BNL Update 11/8/2016

Injection Molded Lightguides Q/A

Markings from mold:

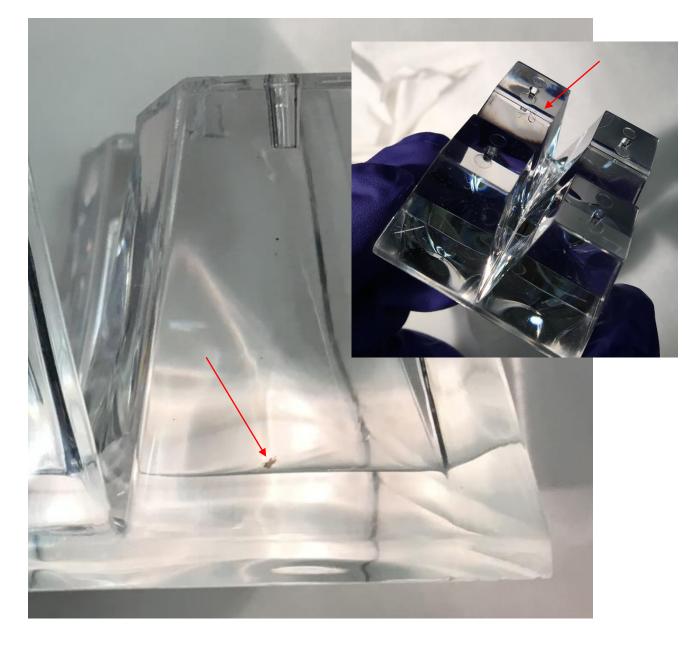
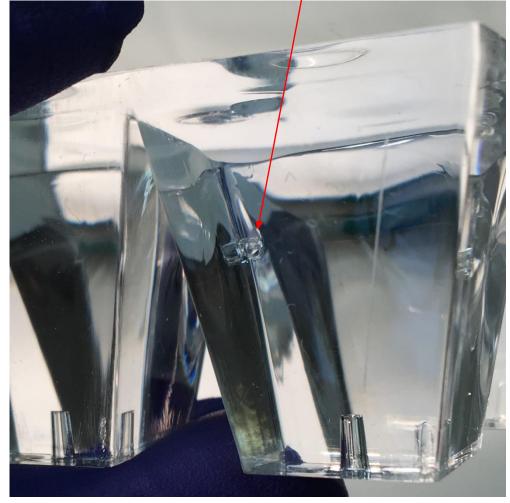
Top: ejection marks

bottom: gate (fill point) mark

Both of these will be machined away when the parallel surfaces are machined and polished.

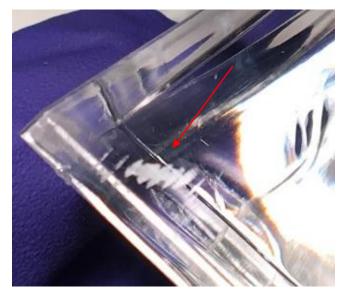
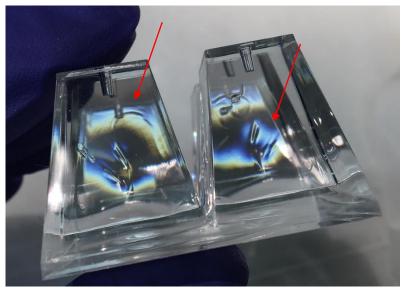
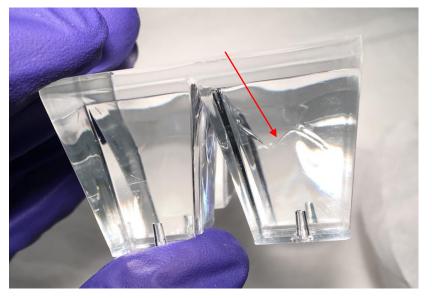
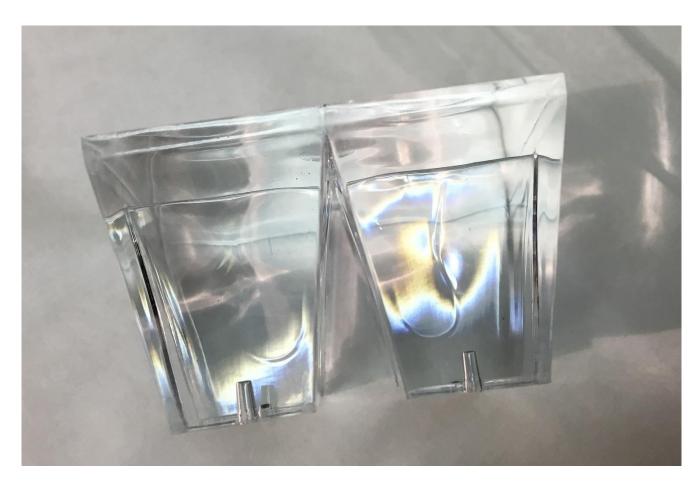
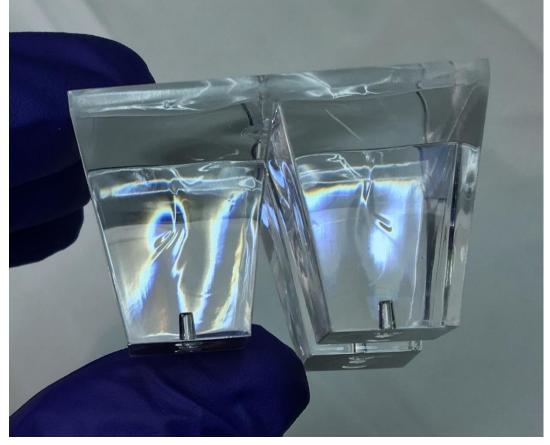
- Noted that many of the pieces have deformed (since arrival?)
- Tapped holes have moved by as much as 1mm, so would not fit with sipm/pcb.
- First 2-3 taken, machined and polished have not deformed significantly Does machining reduce thermal stress in part?
- ProtoLabs Process engineer and materials engineer say that effect is due to part thickness. Parts this thick may take 2-3 days to set.
- We have ~10 that have been machined and polished for the prototype.
- We considered ordering a second batch of the 1" LG's and then machining them quickly after they arrive. But since we already have enough for ½ of the prototype – it would be more productive to move ahead with the longer version.
- Tentative plan is to order 100 w/ expedited delivery, then machine them quickly once they arrive at BNL.
